**CITY OF MERIDIAN
FINDINGS OF FACT, CONCLUSIONS OF LAW
AND DECISION & ORDER**

Case No(s). H-2024-0022

COMMUNITY DEVELOPMENT DEPARTMENT REPORT

HEARING DATE: 11/19/2024
TO: Mayor & City Council
FROM: Linda Ritter, Associate Planner
208-884-5533
lritter@meridiancity.org
APPLICANT: Laren Baily, Conger Group
SUBJECT: H-2024-0022
Skyranch AZ, RZ, PP and MDA

D. Preliminary Plat (date: 5/22/2024)

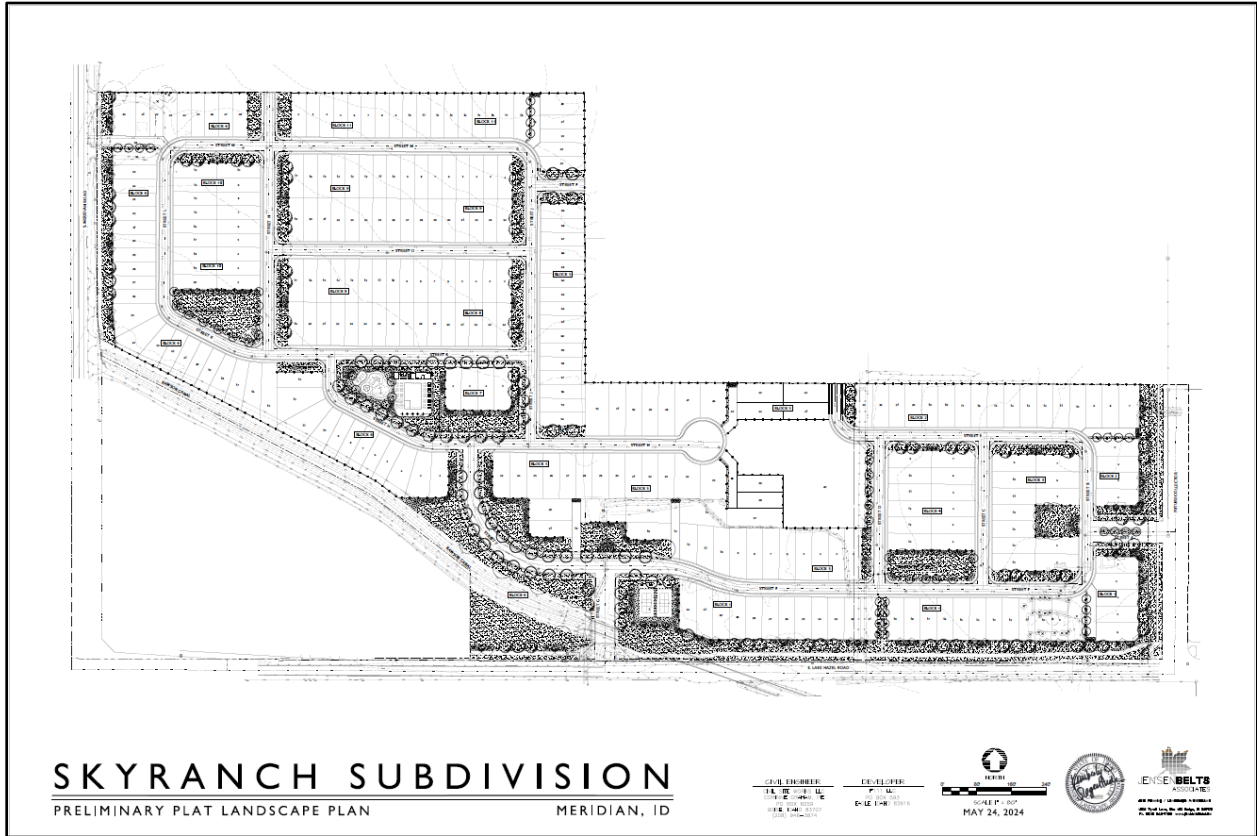
Staff recommends that the applicant provide a mix of dwelling types within the residential area such as single family attached or townhomes within Block 8 (lots 2-17 and lots 19-34) and Block 9 (lots 2-17 and lots 19-34) of the proposed development as allowed by the Comprehensive Plan within the R-15 zoning district.

Per UDC 11-6C-3A.1, through properties are prohibited except where it is shown that unusual topography or other conditions make it impossible to meet this requirement. Through properties shall be limited to one (1) street access on one (1) frontage, designated by a note on the final plat. The applicant needs to revise the plat to remove one of the frontage roads for Lot 40, Block 5.

It appears that some of the block lengths exceed the 750 feet. The applicant did not submit a revised block face length exhibit for review as requested.

- d. All pathways and micro pathways shall be within a separate common lot or easement as required per UDC 11-3A-8.
 - e. Access to Lot 40, Block 5 shall be restricted to either Street H or Street Q. No access shall be allowed to and from the other street until the property redevelops. This shall be added as a note on the plat.

E. Landscape Plan (date: 5/24/2024)

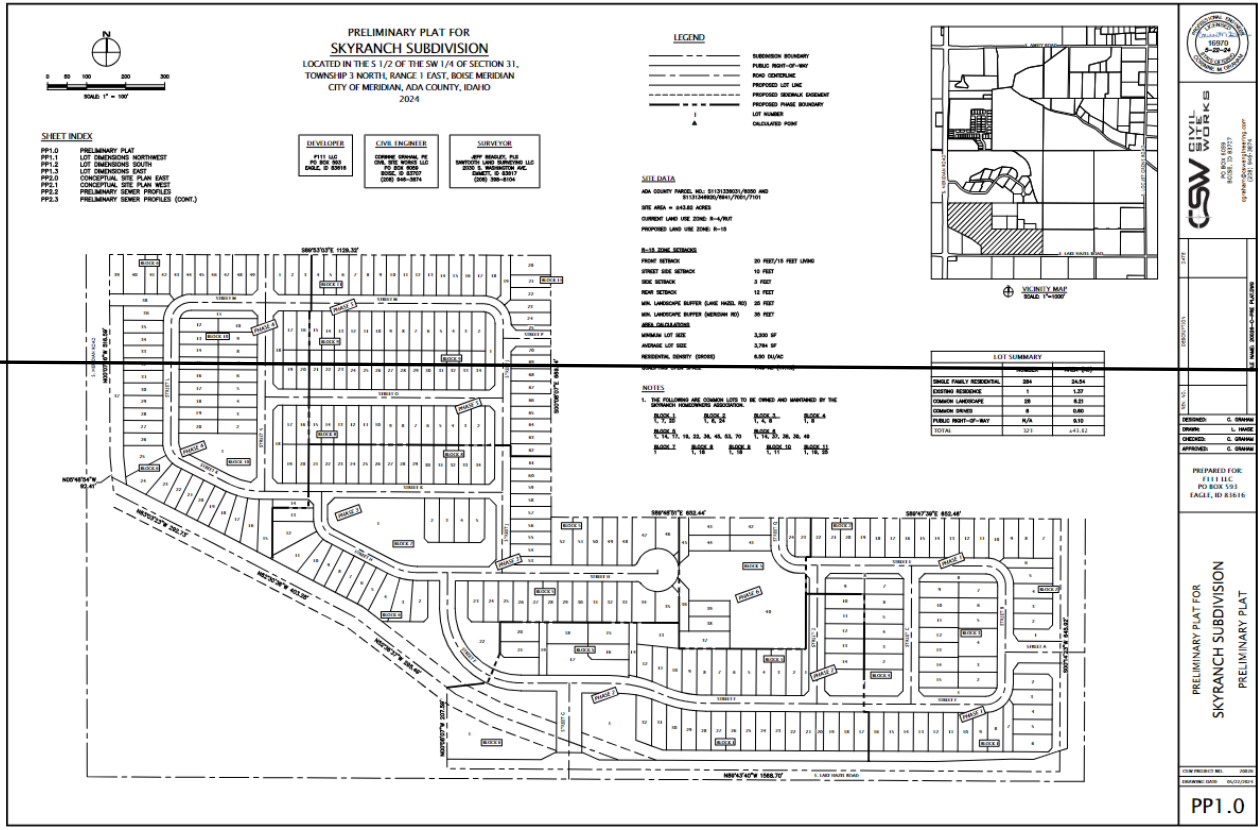
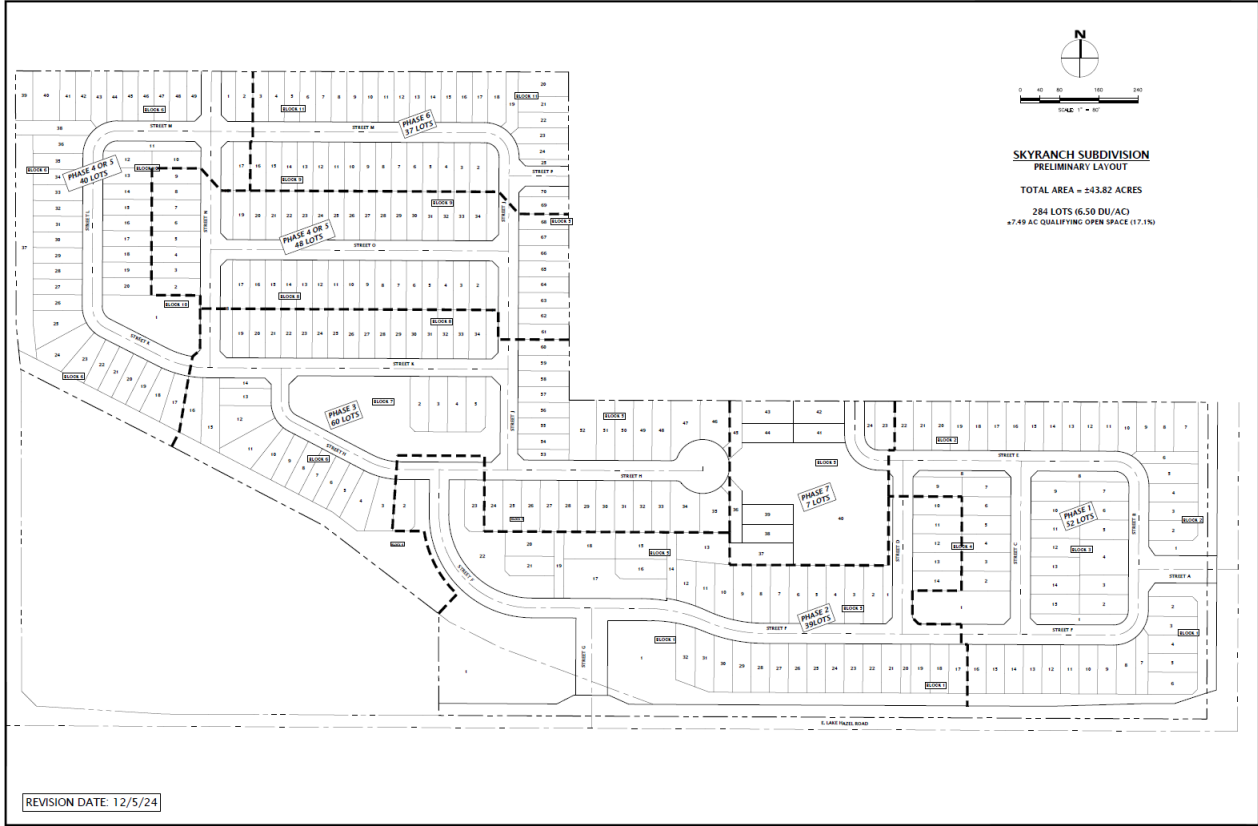
The applicant shall add a mitigation section to the landscape plan for trees meeting the criteria above that are removed.

4. The revised landscape plan shall include the following:
 - a. A mitigation section to the landscape plan for trees meeting the criteria above that are removed.
